PERMIT

SEWAGE DISPOSAL SYSTEM

DEPARTMENT OF HEALTH AND MENTAL HYGIENE

SUBDIVISION Talbot's Last Shift LOT 12C ROAD 5213 Talbots Landing

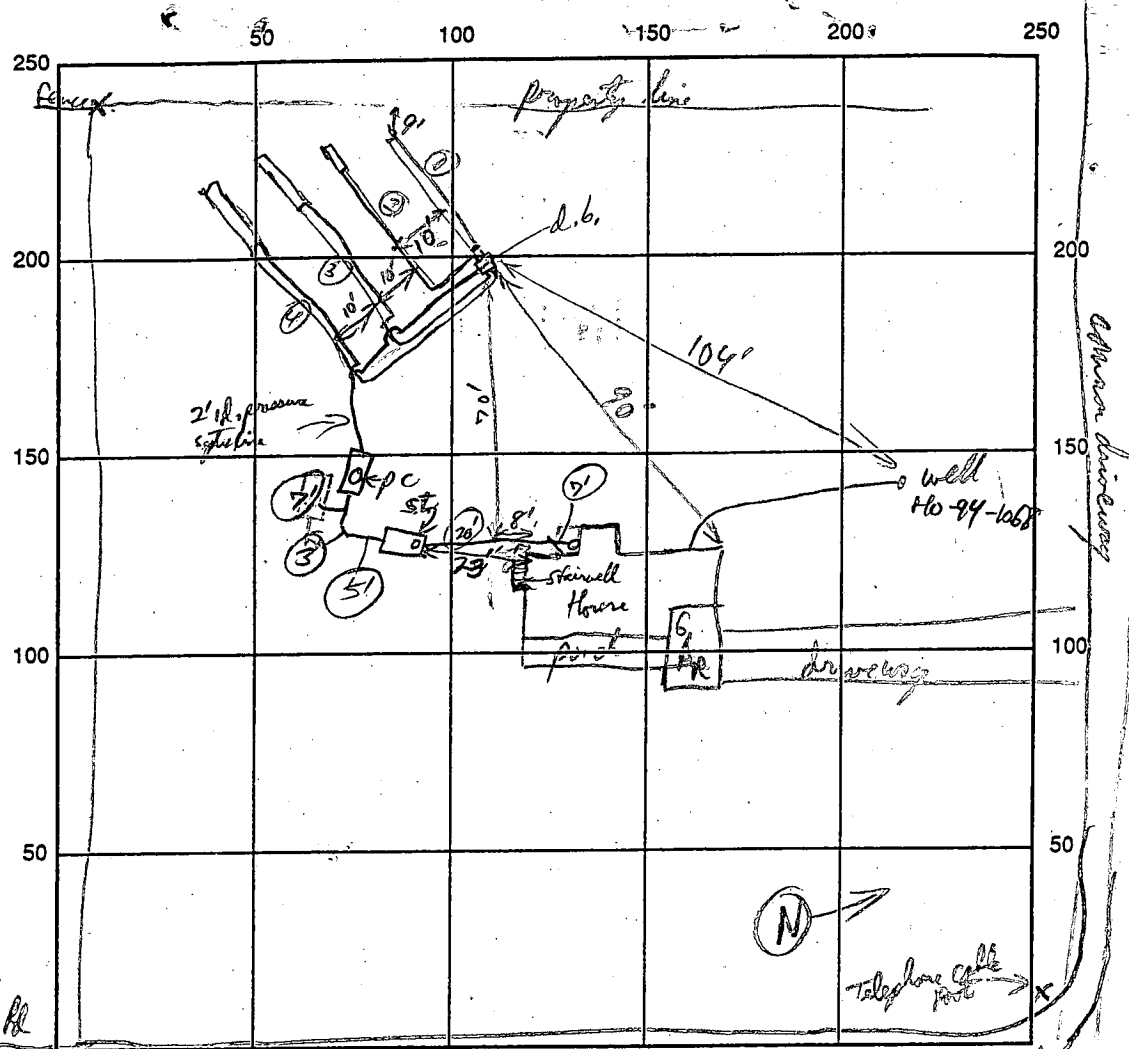
REMARKS: 2/12/98 Installer told to install variable length trenches to utilize all
 of septic area. 3/13/98 Final Trench OK to proceed fill (see Soil Description above) 2/13/98 2 trenches
 installed - ends left open - OK to continue (no contractor on-site) X
 S.T. + Pump Chamber & House connected OK to cover. Needs Pump Test (rest of trench already covered,
 location guessed at for 3+4 Trenches) RP 3/17/98
 3/17/98 - pump system & water line OK to cover RP 4/29/98 PUMP + ALARM OPERATION OK RP
 DATE SYSTEM APPROVED 4-29-98 INSPECTOR Glet. Jang.

SITE PLAN

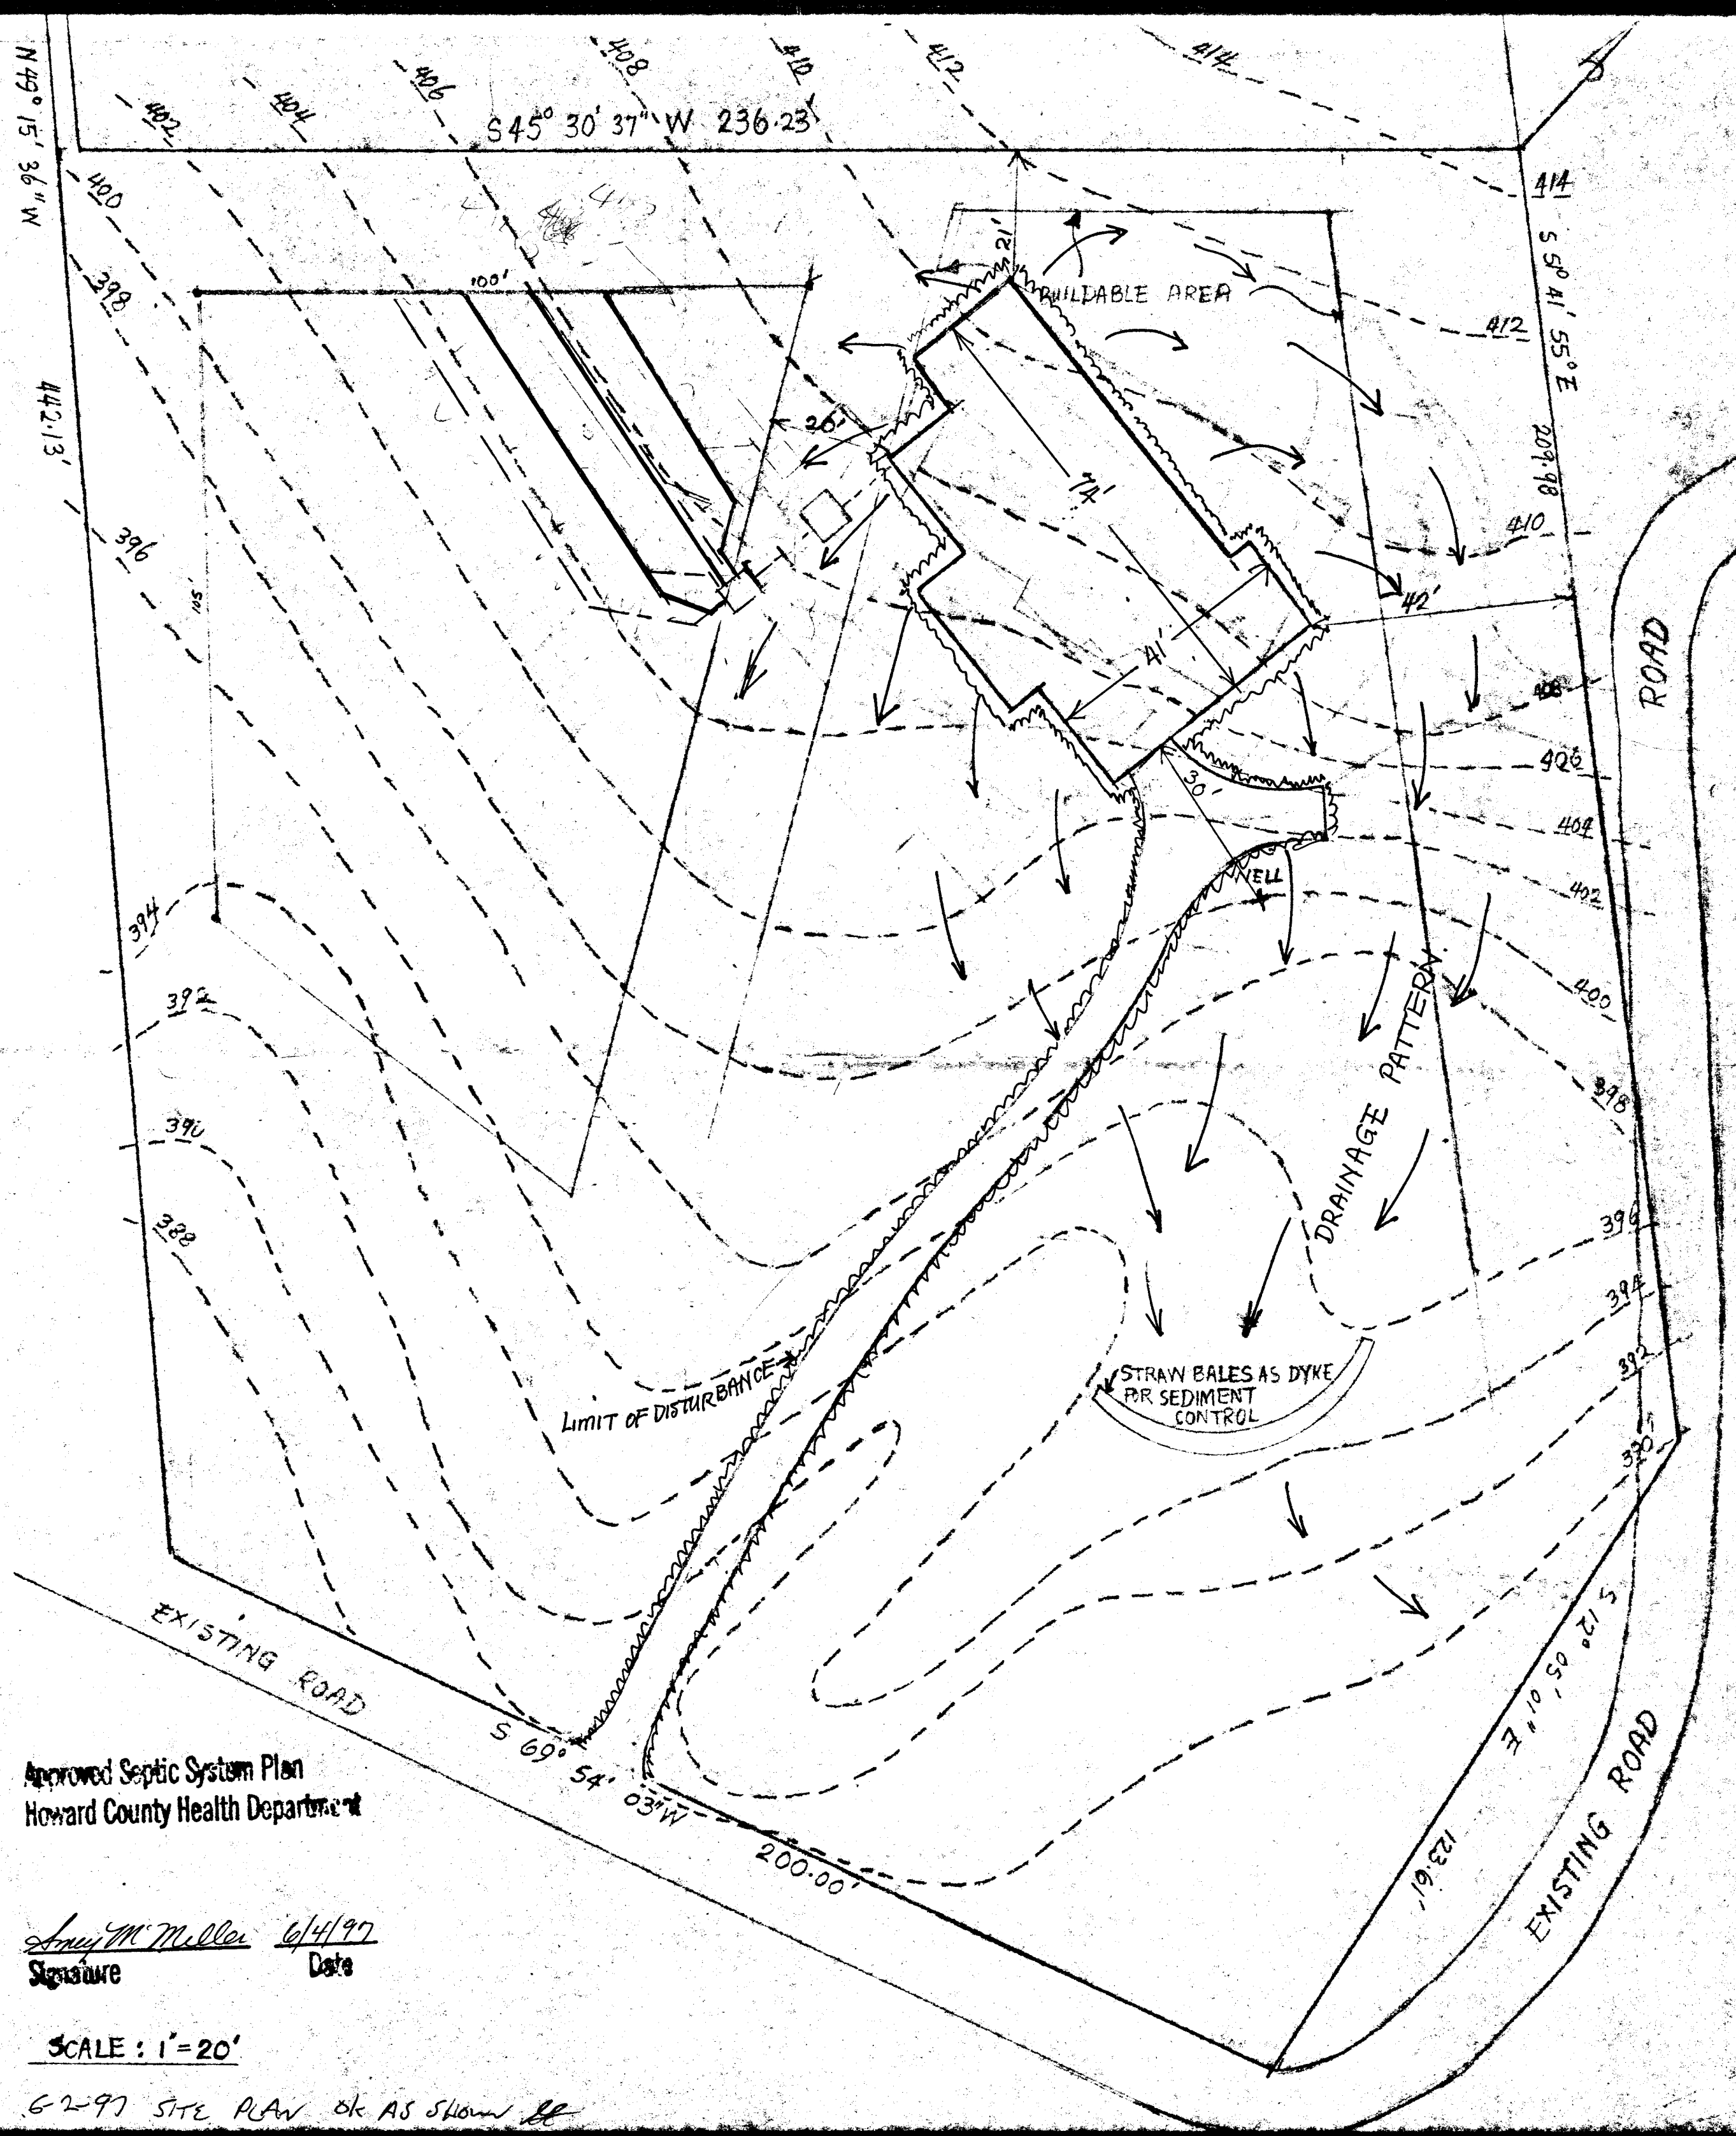
BASEMENT IS NOT SERVICABLE
 BY GRAVITY TO THE SEPTIC
 SYSTEM.

6-2-97 SITE PLAN ok AS SHOWN

SITE PLAN

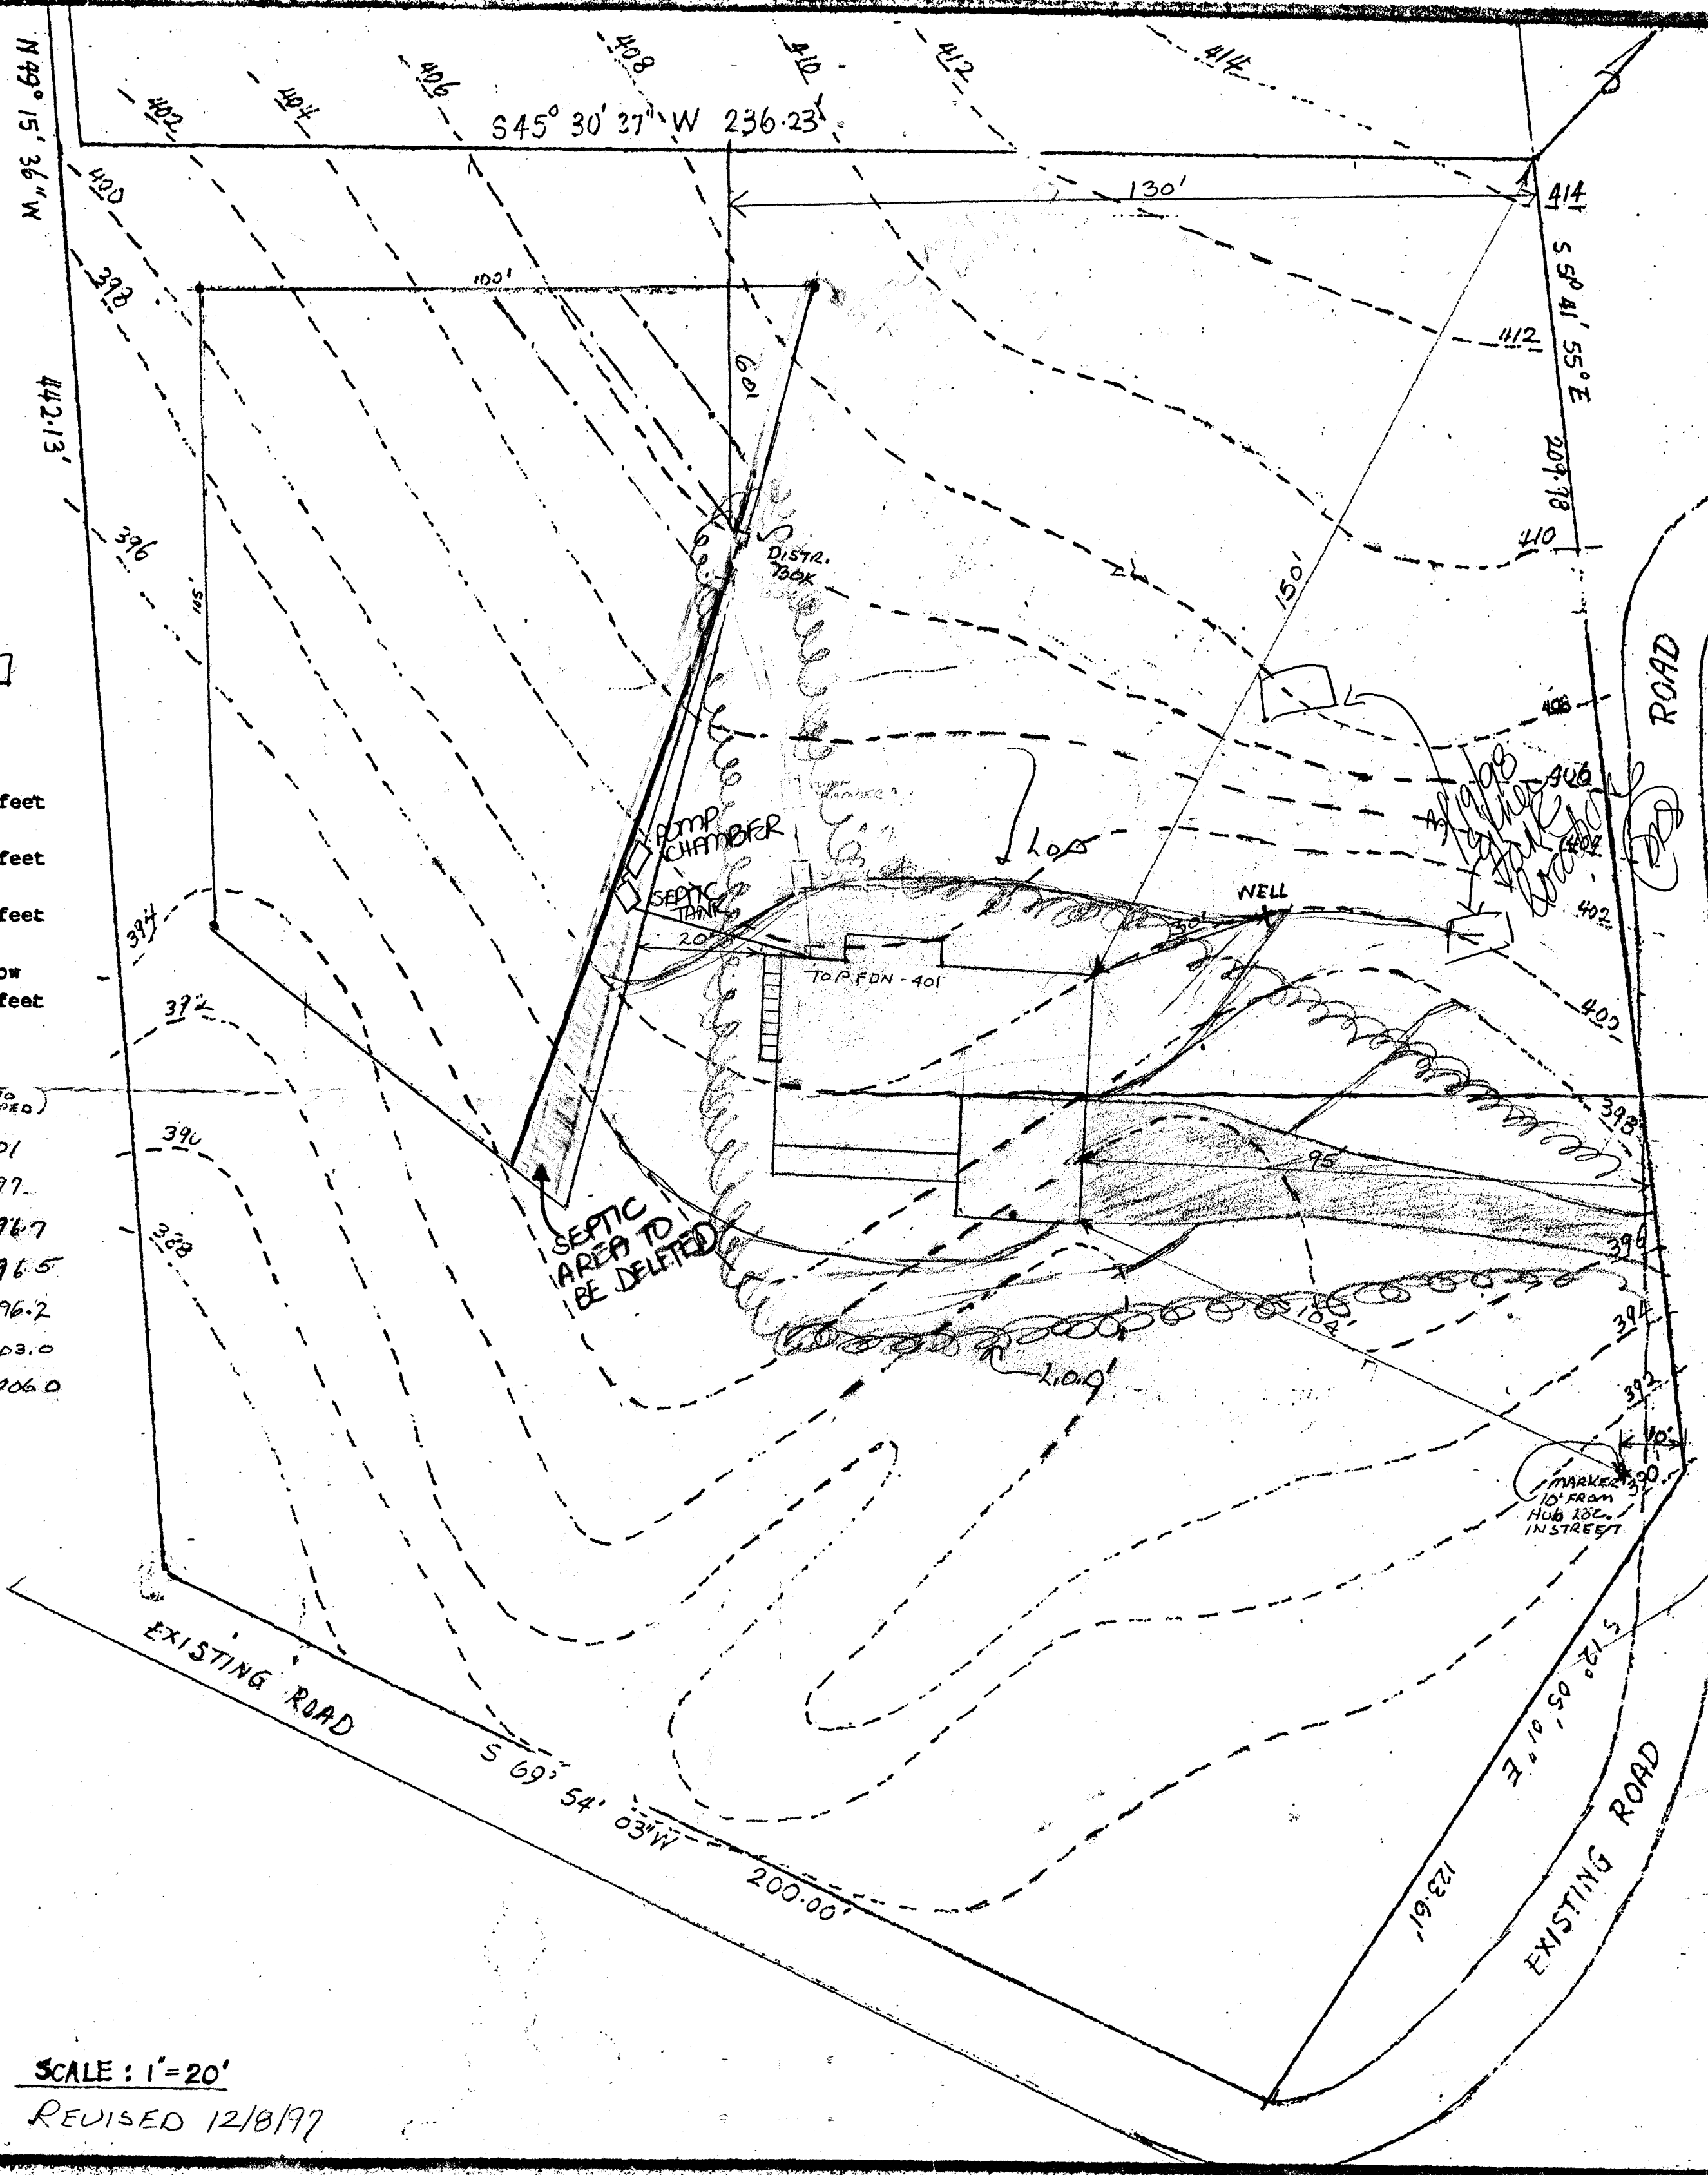
REVISED
Date: 12-8-97
5213 Talbot's Landing
B00108971
Comments:
Change house location
to meet health Dept
requirements
